Response to Reviewer 1

We would like to thank Reviewer 1 for the comments and remarks which significantly improved the manuscript. Please find our revisions and replies to the general and specific comments below. Line numbers in blue square brackets refer to the line number in the uploaded revised manuscript with tracked changes.

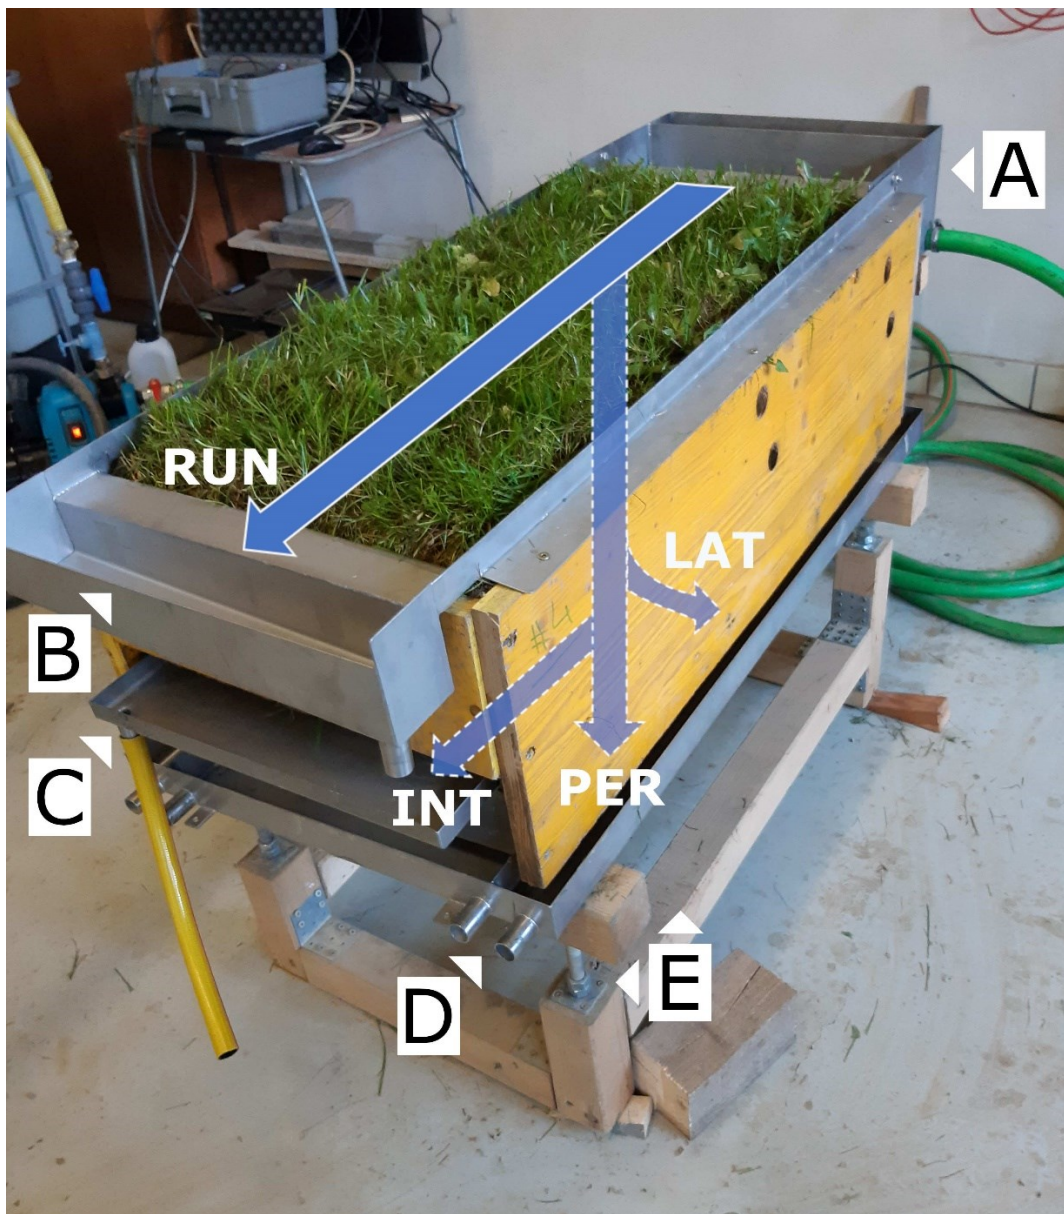
R1: Figure 1: Annotate arrows to show slope direction (from overflow tank to outflow at the bottom) for clarity. Also, it would be helpful to annotate key hydrological processes (surface runoff, sub-surface interflow, percolation, laterally exported water) as arrows.

Answer: We changed Fig. 1 accordingly:
